## V3 - SDP-23-08 Tidal Wave Car Wash

# TIDAL WAVE AUTO SPA ROLESVILLE, NC, USA TOWN PROJECT ID # V1-SDP-23-08

C1.0

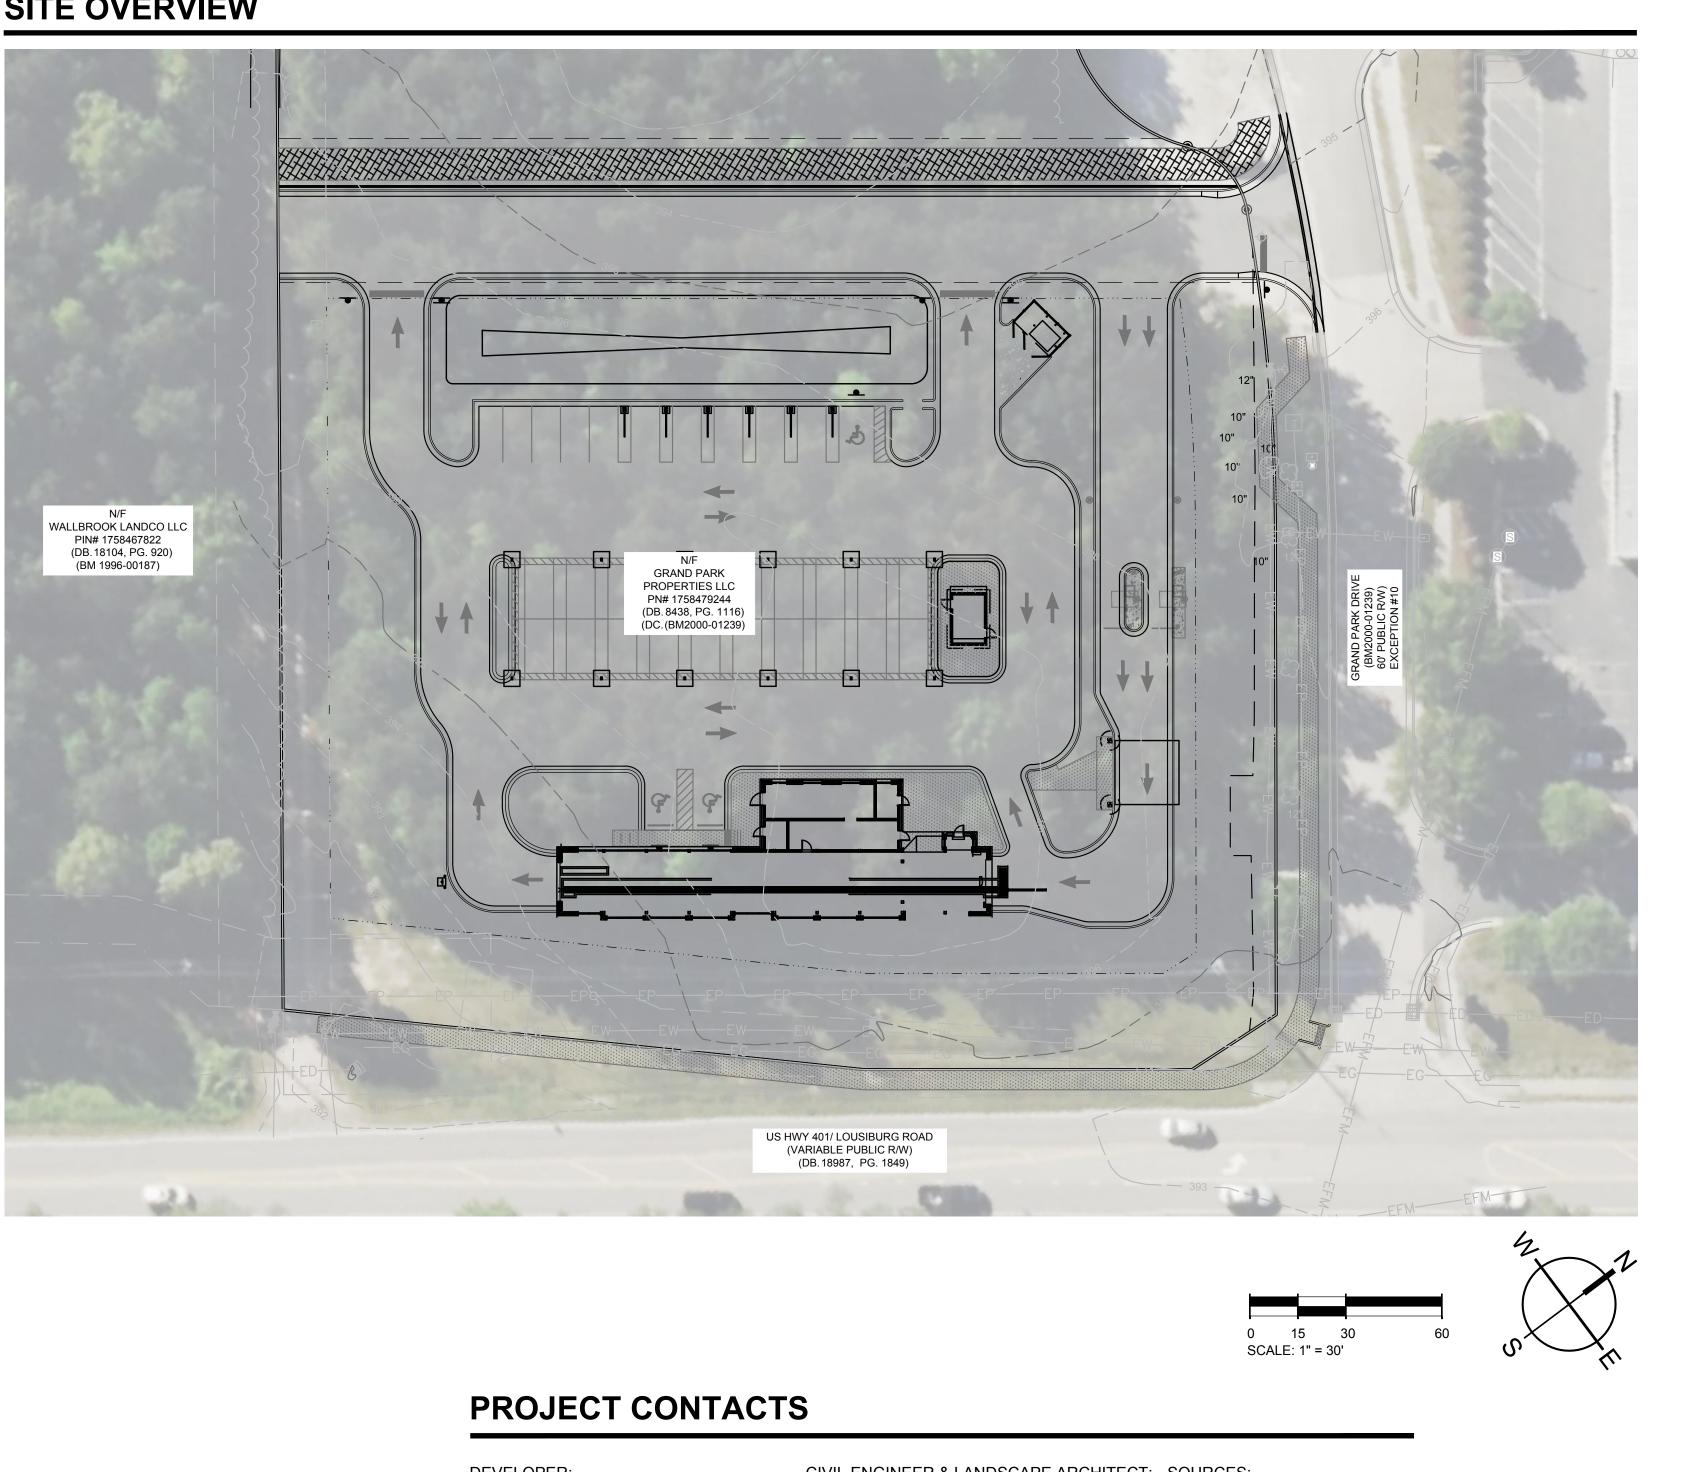
future connections to parcel.

) Include SWM report with next submiss

l-da-sac)

.) REPEAT: Provide utilities for all Parcels being subdivided from Master Parcel.
 1a.) COR has concerns with the Subdivision/splitting of this parcel. With parceling of this site the northwest parcel will need to be provided Utilities (water and sewer) for 1b.) COR requires the extension of utilities (water and sewer) to each parcel off of

Grand Park Drive Lot 2 to be split for Tidal Wave (A/B) and Lot 6 does not have service(s) either. Depending on WL size along Grand Park. Note that the North Iture half) parcel of Lot 2 of the site is lower (concern to get gravity sewer)?

) REPEAT: Confirm the intent to build the cul-de-sac for development (platted with

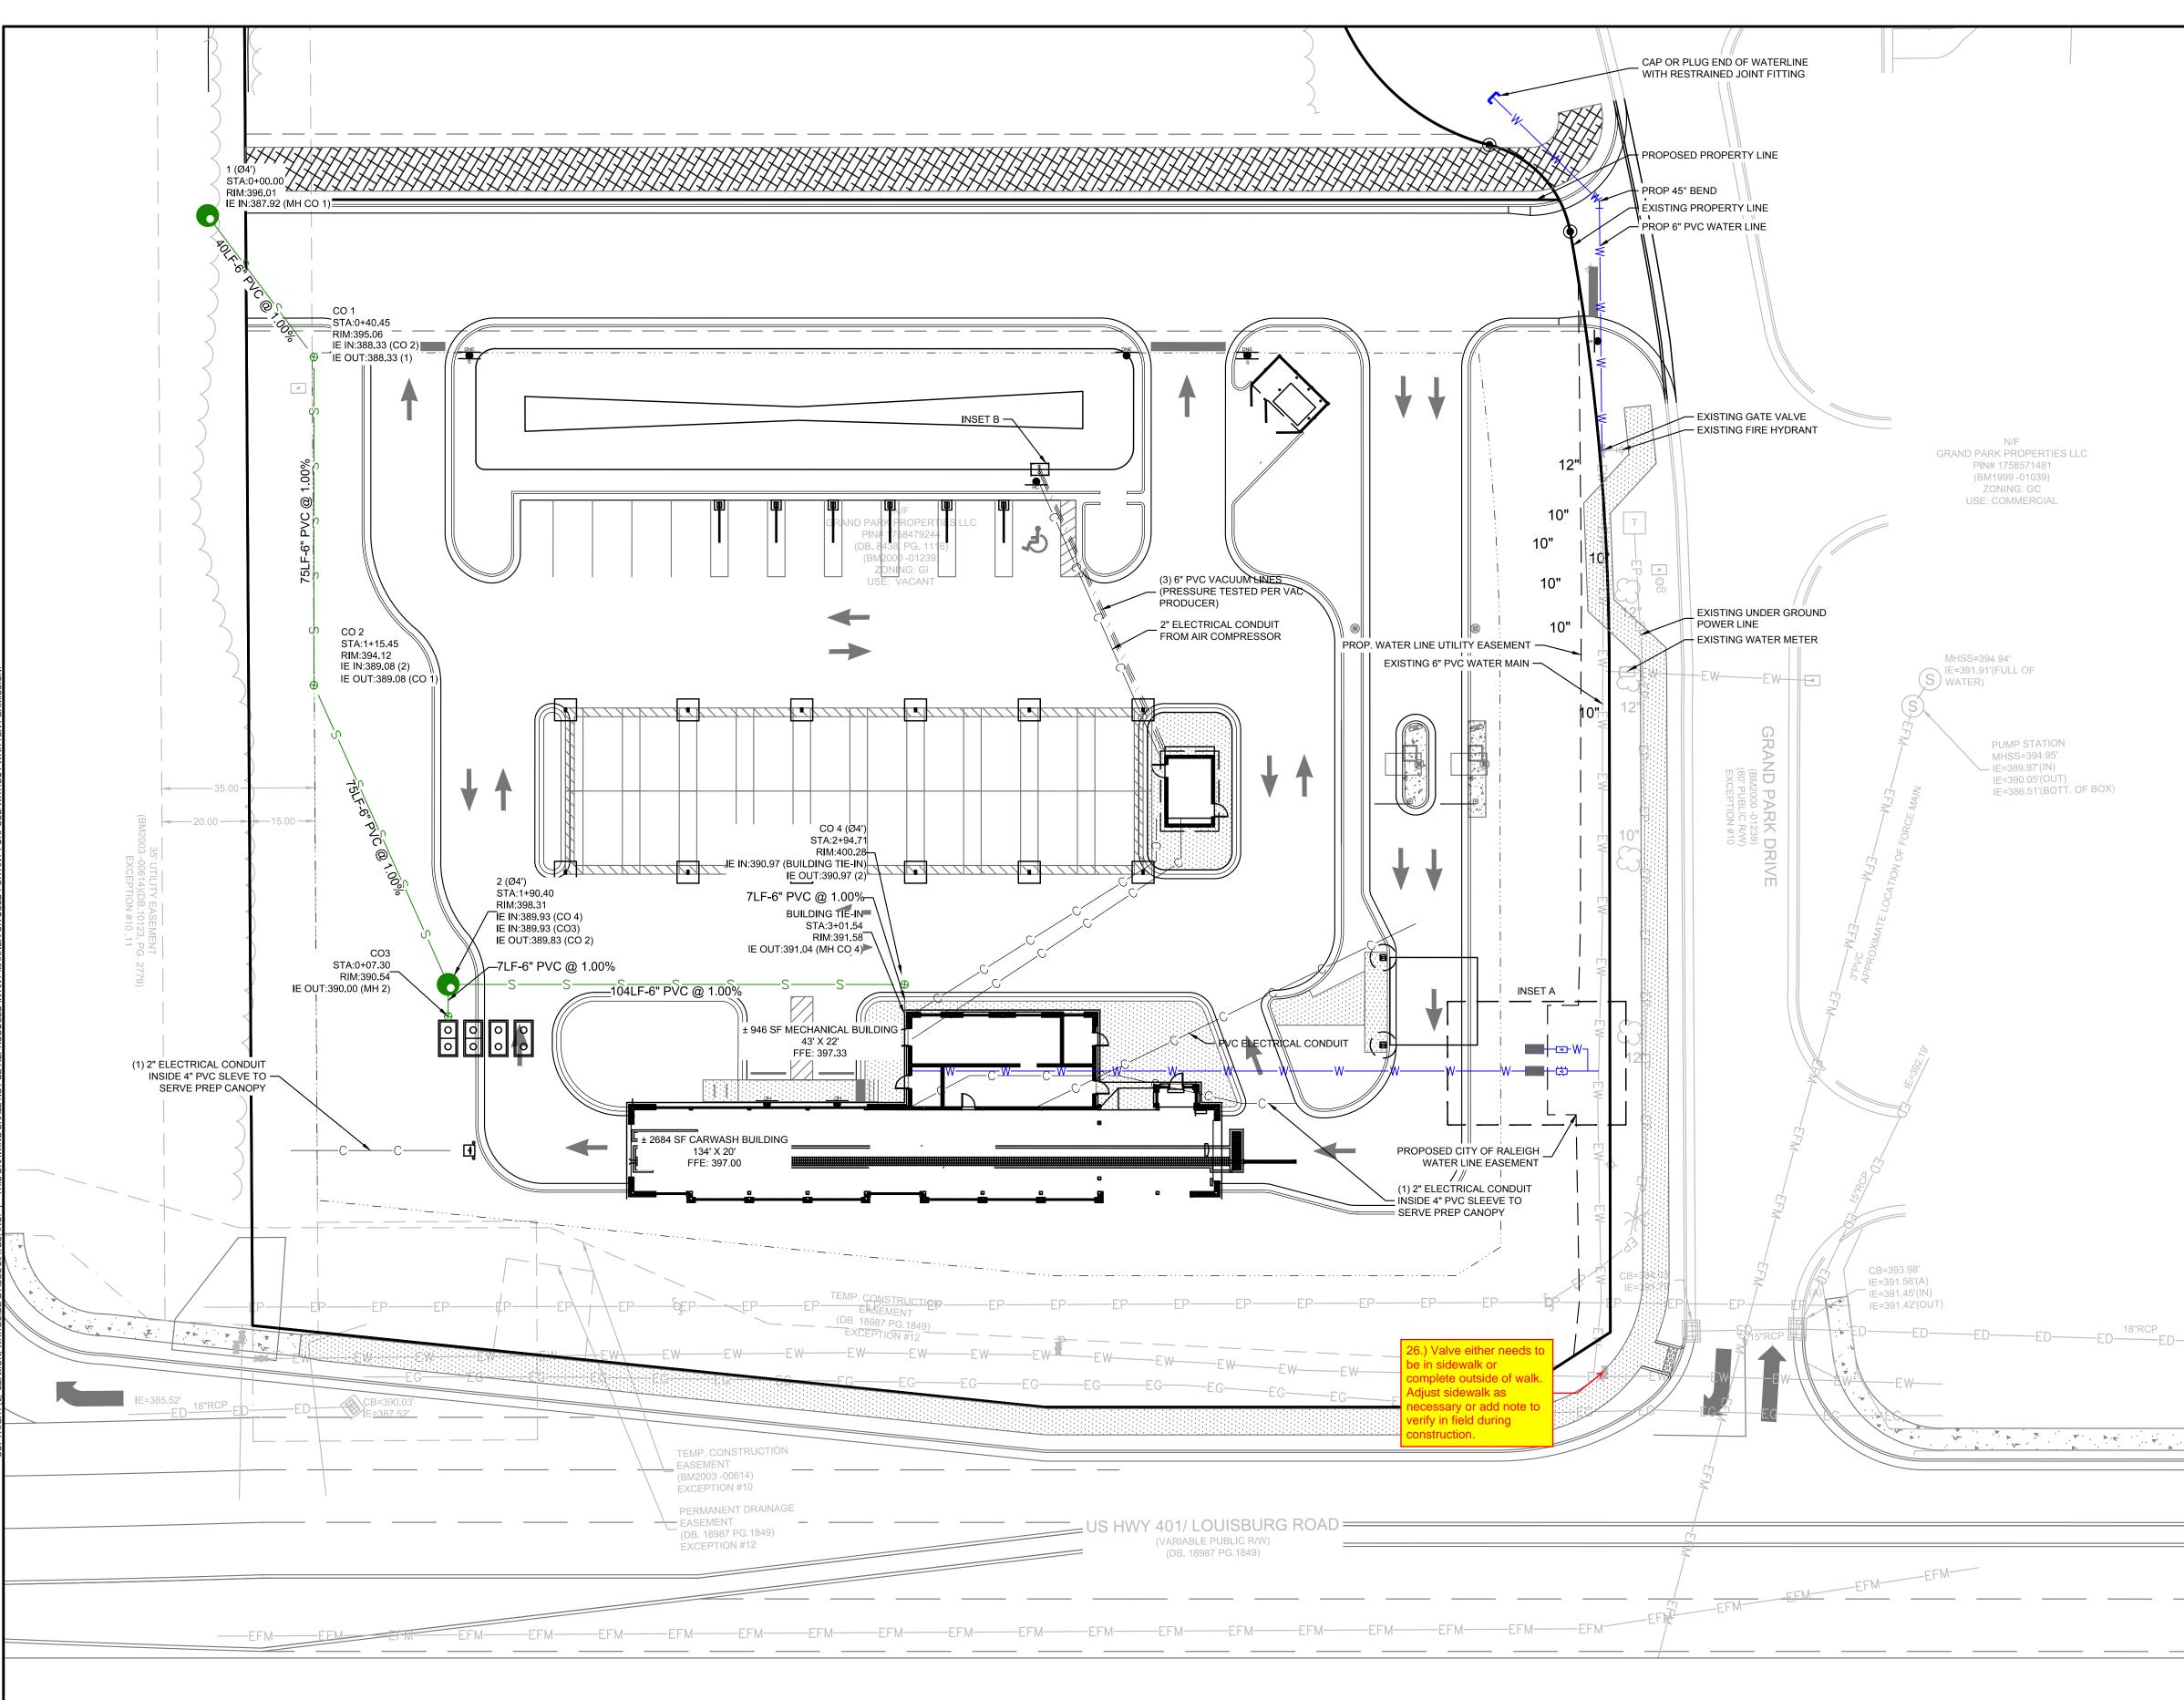
25.) Include profiles
